LINCOLN CITY/LANCASTER COUNTY PLANNING STAFF REPORT

P.A.S.: Special Permit No.05011

PROPOSAL: Community Unit Plan for 38 dwelling units.

SITE PLAN
VINTAGE HILLS ADDITION
C.U.P. SPECIAL PERMIT #
LINCOLN, NEBRASKA

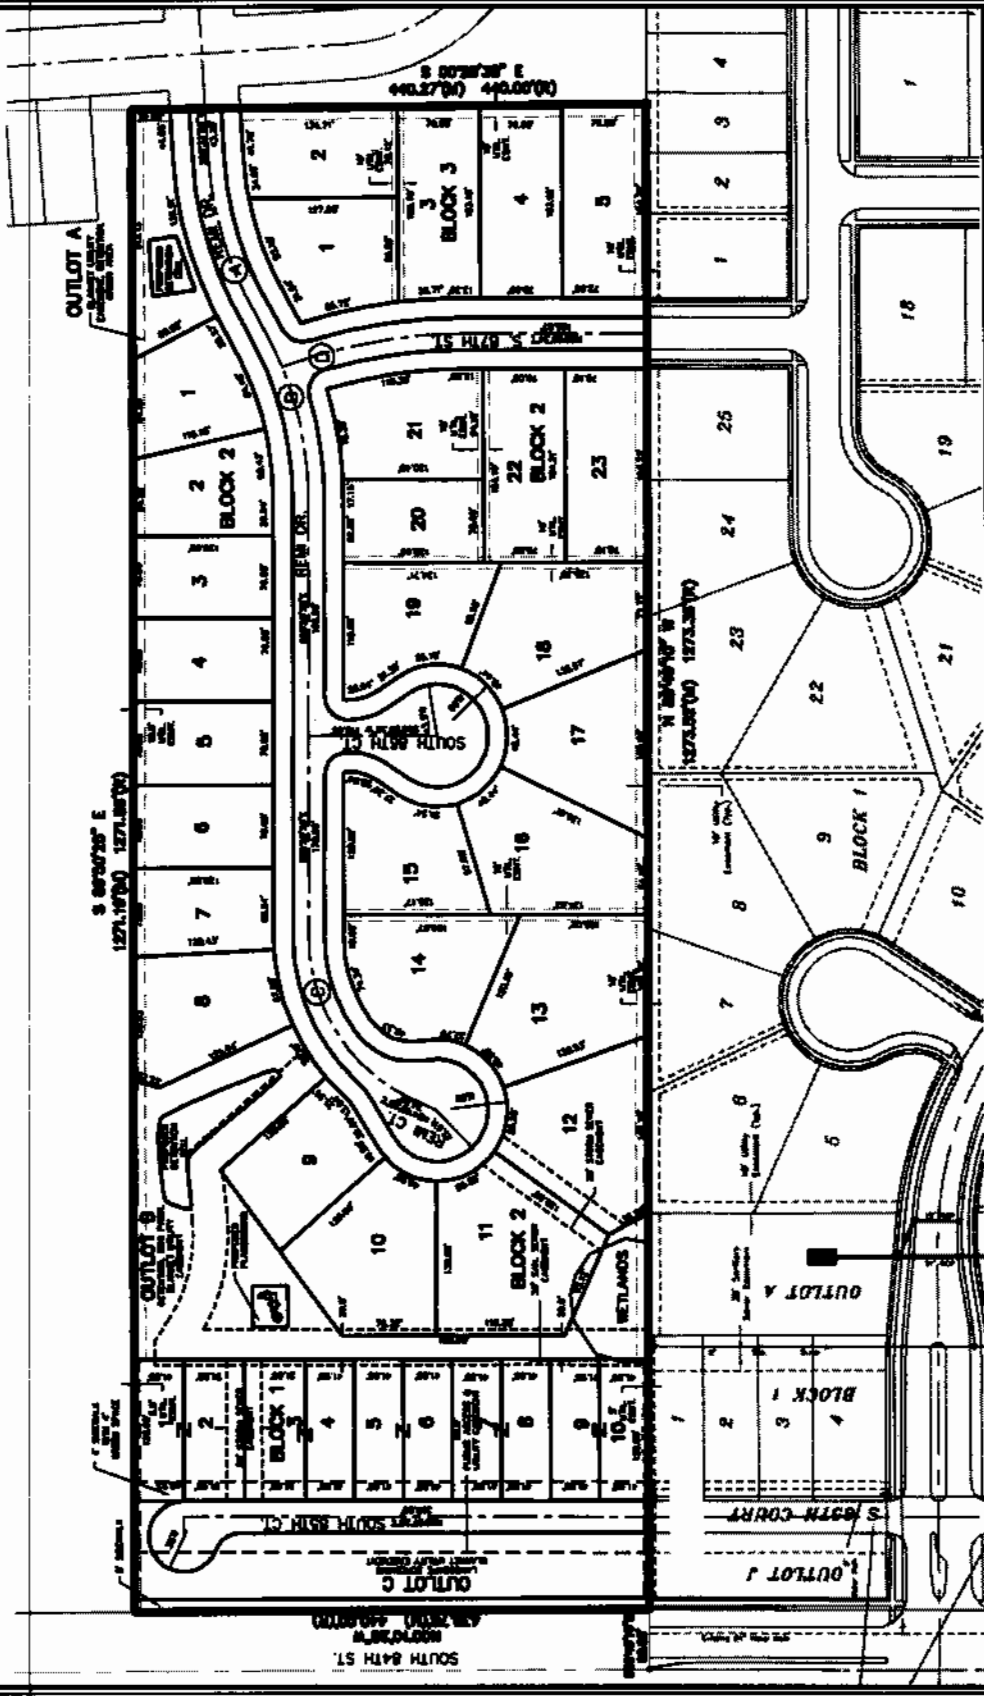
- **Sanitary Sewer** - The following comments need to be addressed.
 - (1.1) The sanitary sewer serving Lots 1-10 Block 1 should be located adjacent to 85th Street instead of along the back of the lots across open ground. This will better accommodate required maintenance activities.

- **Water Main** - The water system is satisfactory.
- **Grading/Drainage** - The following comments need to be addressed.
 - (3.1) Routing calculations need to be provided for the proposed detention cells. The volume calculations provided are sufficient for an estimate of required storage. However, design standards and the Drainage Criteria Manual require that routing calculations be provided.

- (3.2) Emergency overflows need to be shown on the plans for the proposed detention cells as per design standards and the drainage criteria manual.
 - (3.3) A 2% minimum slope needs to be maintained on the floor of the proposed detention cells as per design standards and the drainage criteria manual.

- (3.4) There is a significant amount of offsite flow drain from the Boulder Ridge development to the south of this plat. The proposed grading for this plat shows blocking the natural drainage path for this flow and the storm sewer pipe shown to capture this flow is drastically undersized for the amount of flow that is being discharged. The grading and site plan needs to be revised to the satisfaction of Public Works to account for this drainage way or the storm sewer needs to be sized to convey the 100 year flow. Also, the drainage study must show calculations and a design that accounts for the 100 year flow path along all areas of the concentrated flow.

(3.6) The east detention cell will not function as shown on the plans. There is a significant amount of drainage that does not reach the cell. The storm sewer system is designed for the 5 year storm and there is no overland flow route to direct the flow from storms greater than the 5 year event to the cell. The grading and site plan needs to be revised to the satisfaction of Public Works to account for this drainage or the storm sewer needs to be sized to convey the 100 year flow.

(3.7) The receiving storm sewer system for the east detention cell is designed for the 5 year storm according to design standards. The east detention cell will need to be sized to account for the restricted receiving system. The cell will need to be expanded to accommodate the 10 year and 100 year storm events. The grading plan and detention calculations need to be revised to the satisfaction of Public Works.

(4.1) The public access easement in South 85th Court on the Boulder Ridge plat stops 5' short of the property line. This easement will need to be extended to the property line in order to provide access to this plat. This developer will have to provide information showing that the easement will be extended by the Boulder Ridge development.

ALLTEL, Time Warner Cable, and the Lincoln Electric System will require the additional easements marked in red on the map.

2.1.1.1 Delete "mini-park" from Outlot "B".

2.1.1.2 Show utility easements as requested by the LES memo of March 4, 2005.

2.1.1.3 Relocate the sanitary sewer from Outlot "B" to S. 85th Ct.

- 2.1.1.4 Make corrections per Public Works memo of March 11, 2005.
- 2.1.1.5 Remove the City Council approval block.
- 2.1.1.6 Delete items 2,3 & 6 in Note 19 and add the waiver to allow sidewalk on one side of S. 85th Ct.

- 2.1.1.7 Add the attached single-family symbol to the legend.
- 2.1.1.8 Dedicate 10' of additional right-of-way along S. 84th St.
- 2.1.1.9 Identify S. 85th Ct. as a private roadway.

- 2.1.1.10 Sign the surveyor's certificate.
- 2.1.1.11 Show a sidewalk from Remi Dr. through Outlot B to the playground and to the sidewalk on S. 85th Ct. The sidewalk must be within a 5' pedestrian easement.
